**Major Project Concept Plan Application for 19 Storey Mixed Use Development
at 71-79 Macquarie Street, Sydney
Re Major Project Application No. MP10_0237**

**MP 10_0237 - CONSTRUCTION OF A MIXED USE DEVELOPMENT
AMATIL BUILDING, 71-79 MACQUARIE STREET, SYDNEY**

Photo 6: Balconies fronting East Circular Quay following a curved facade

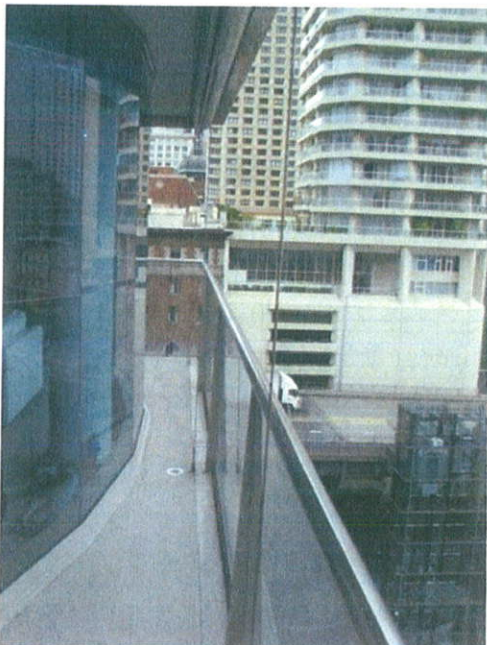
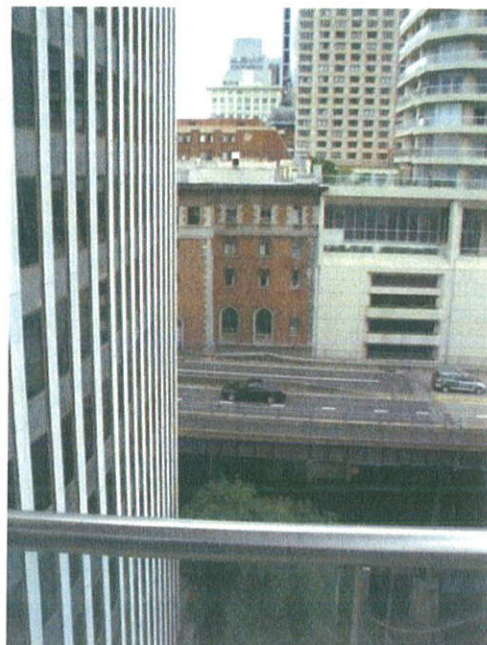
The proposal will also result in view loss for some of the residential units in the Quay Grand, in particular views south from living areas and from balconies (refer to **Photo 6 and 7** above). Of note, this view loss from the Quay Grand units has not really been acknowledged or addressed within the Concept Plan Application submission.

A revised building envelope and/or additional chamfer at the north-west corner of the proposal will appropriately address this matter and maintain existing views from units as well as existing views from the pool area.

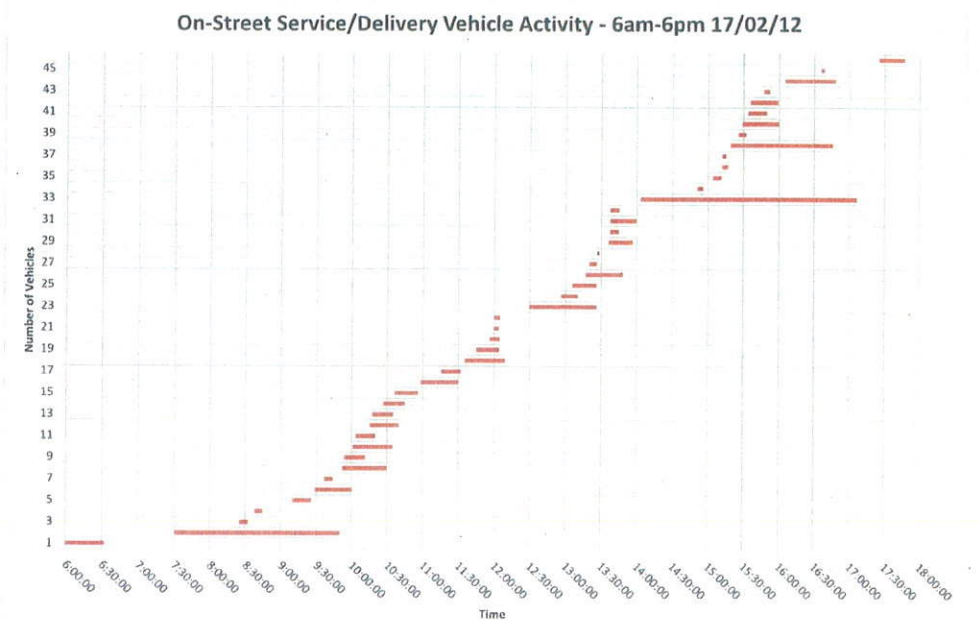
In effect, the *Halcrow* report ignored service vehicle parking that may have occurred elsewhere in the section of public road proposed to be closed.

As part of this assessment, a survey of service vehicle parking *anywhere* within the confines of the road proposed to be closed was undertaken on Friday, 17 February 2012 between 6am-6pm. The results of those surveys are summarised on the graph below and reveal that:

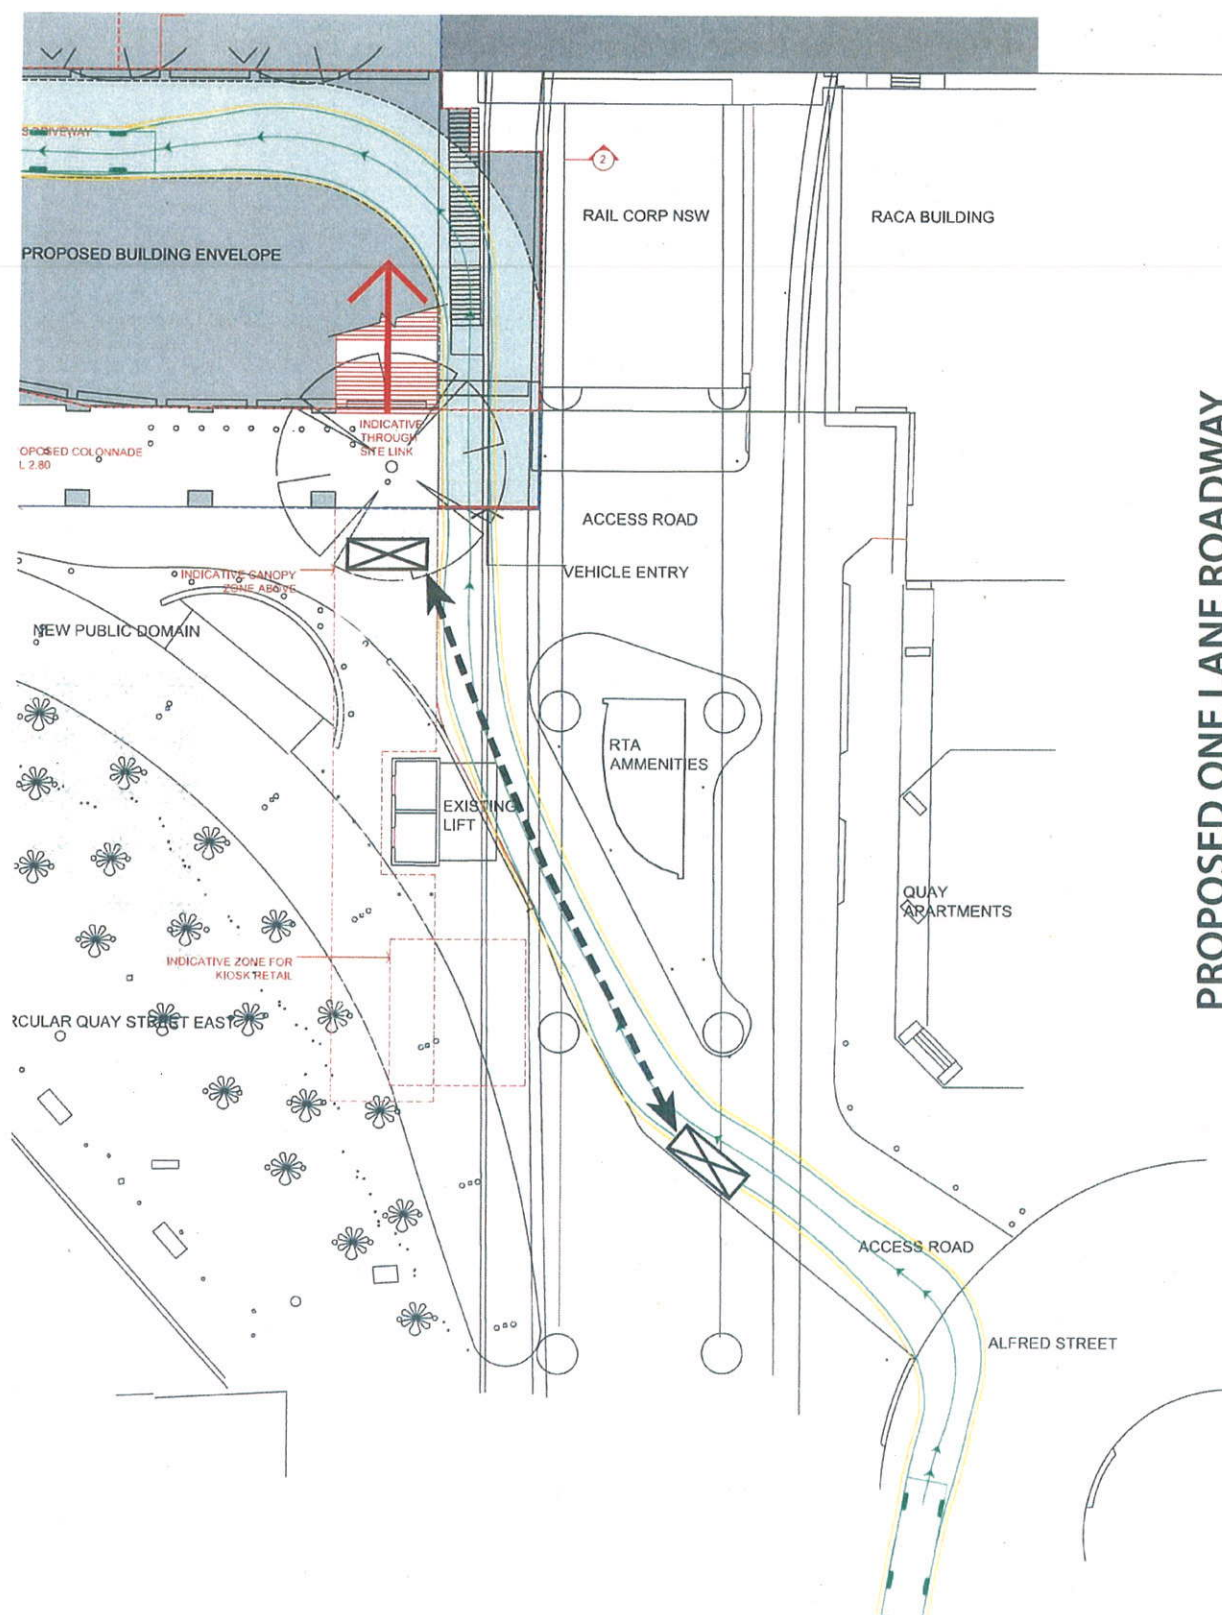
A vehicle wishing to exit the “Quay Grand” site would therefore have to wait near the boundary of the two sites as illustrated on Figure 2, clear of the truck manoeuvring area. Beyond this point the vehicular access arrangements are effectively restricted to a *single lane* arrangement, as illustrated on Figure 3.

In effect, the length of *single* lane roadway providing access to the “Quay Grand” has been more than doubled with the closure of the existing two-way passing area at street level, in front of the Amatil building.

- the internal aisle proposed within the new building (which will provide access to the “Quay Grand” building) should be increased in width to a minimum of 6.5m in accordance with the requirements of *Table 3.1* of *AS2890.1*

**PROPOSED ONE LANE ROADWAY
DRIVER VISIBILITY
FIGURE 1**

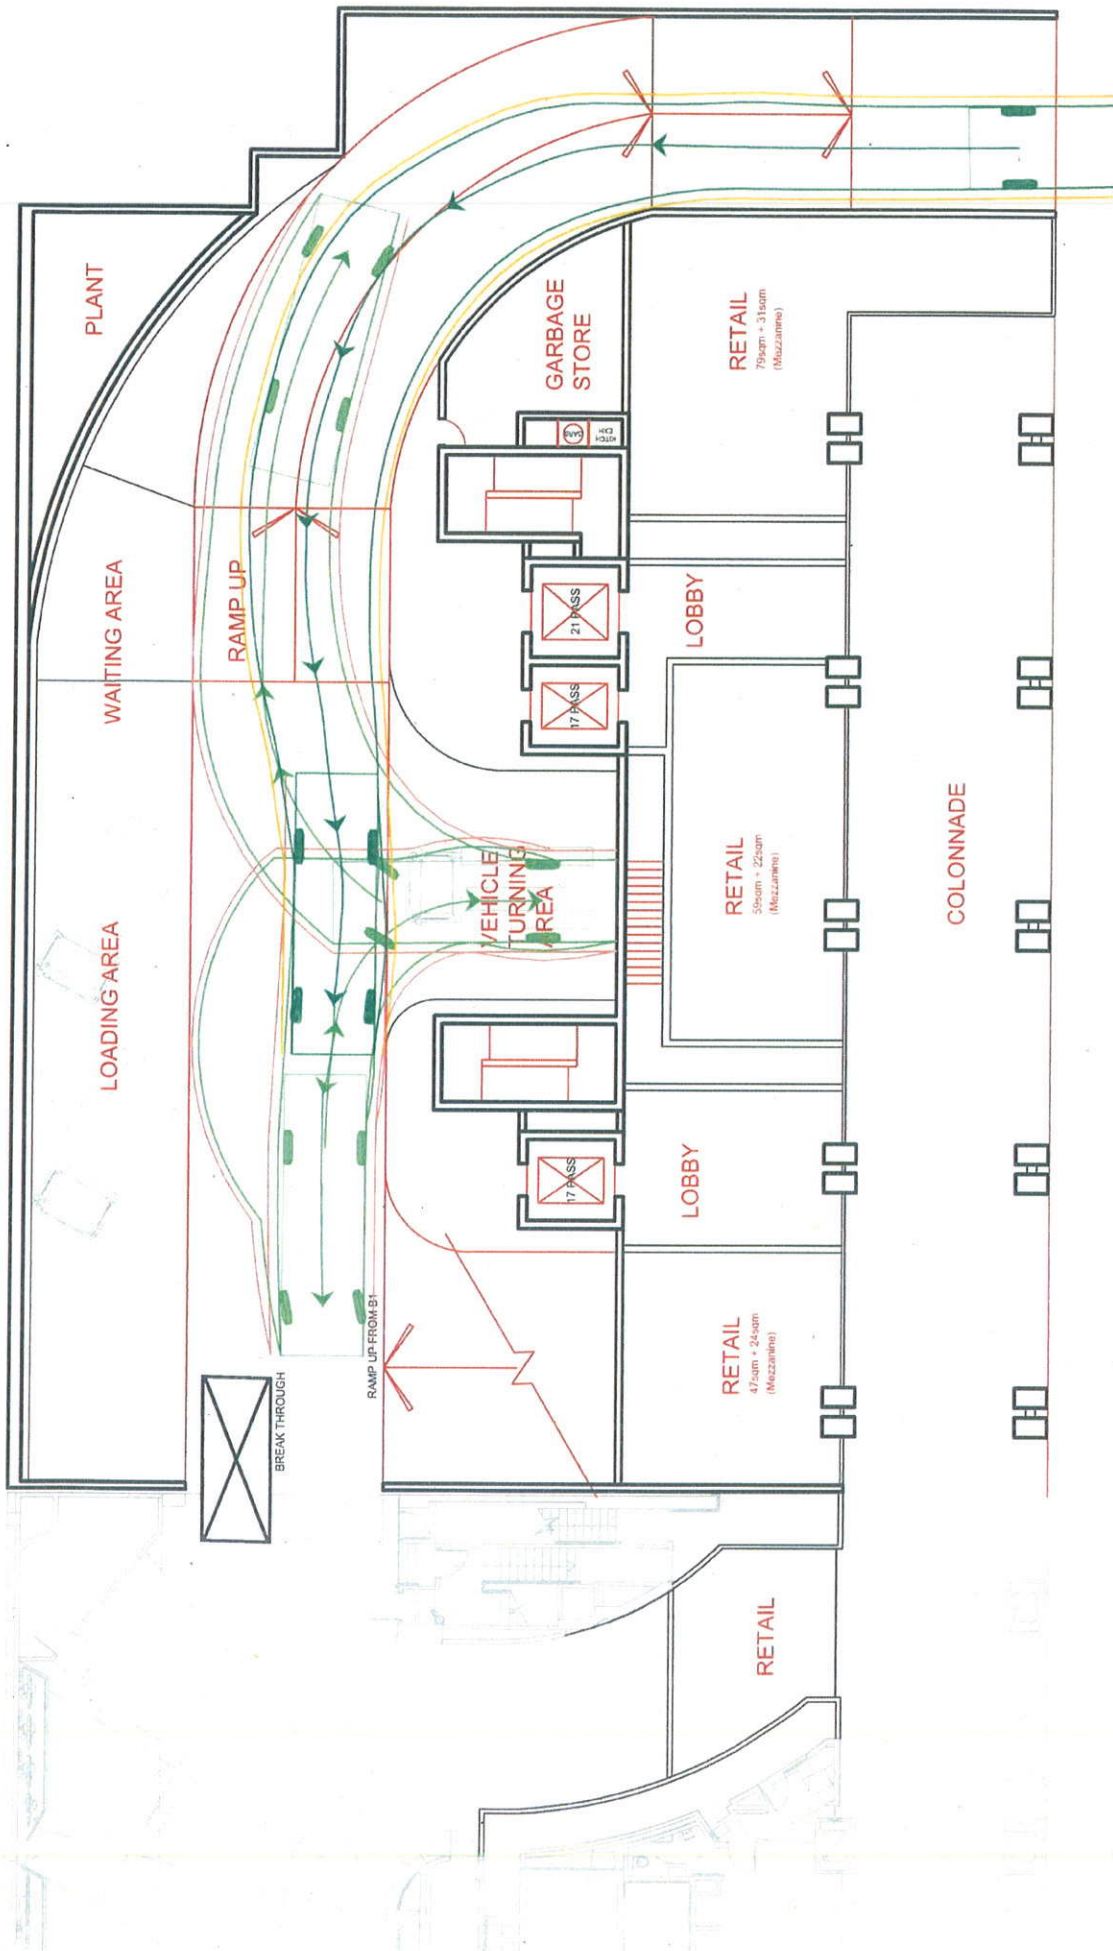
Of particular importance, the existing vehicular access arrangements enable drivers travelling in opposite directions to *see each other* before entering the narrow one-lane section in the Cahill Expressway undercroft area, as indicated on Figure 1.

It is apparent from the plans included in the *Halcrow* report that, under the proposed arrangements, this ability for drivers travelling in opposite directions to *see each other* before entering the narrow one-lane section beneath the Cahill Expressway would *NOT* be possible.

PROPOSED WAITING/PASSING AREA
FIGURE 2

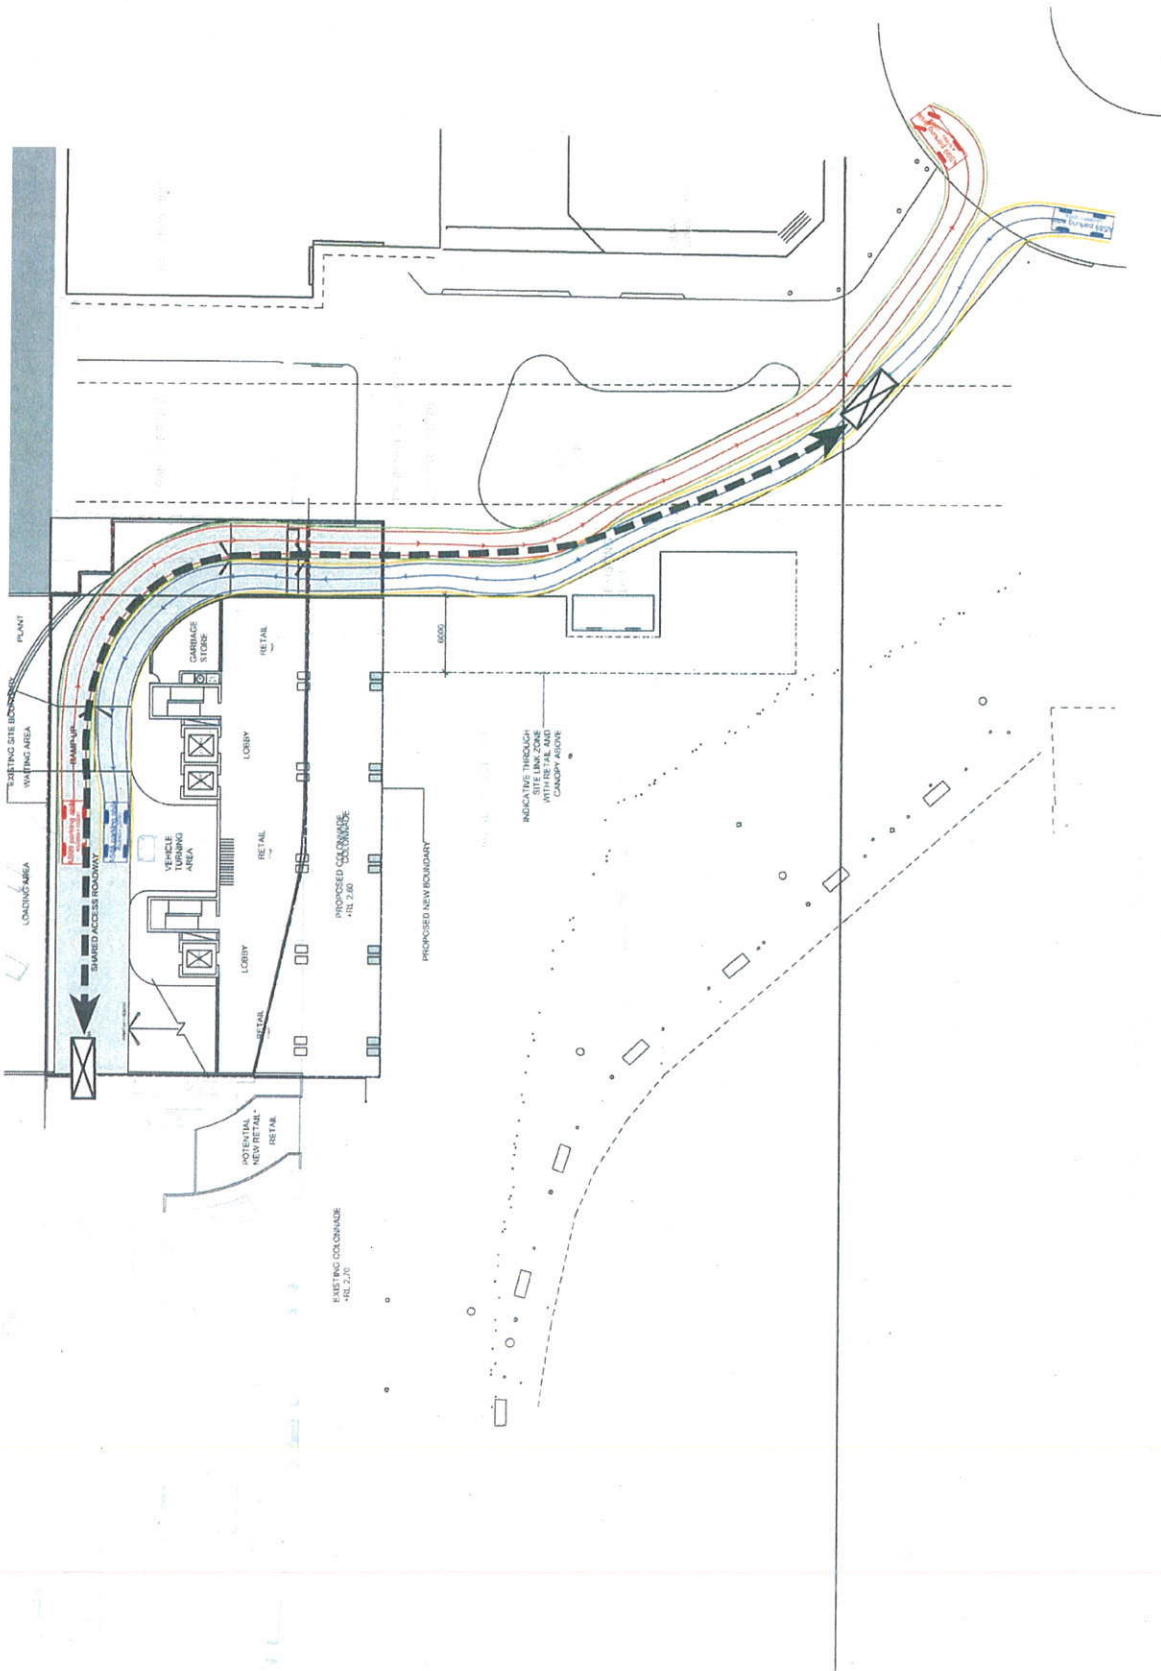
Whilst it is acknowledged that the existing one-lane roadway located in the Cahill Expressway undercroft area cannot be widened, it is considered that the remainder of the access (ie. the new access roadway proposed *inside* the former Amatil building), should replicate the existing two-way passing area as follows:

In particular, the new access arrangements should provide for a truck and a car to be able to pass each other, in the same manner that currently occurs at street level in front of the existing Amatil building.
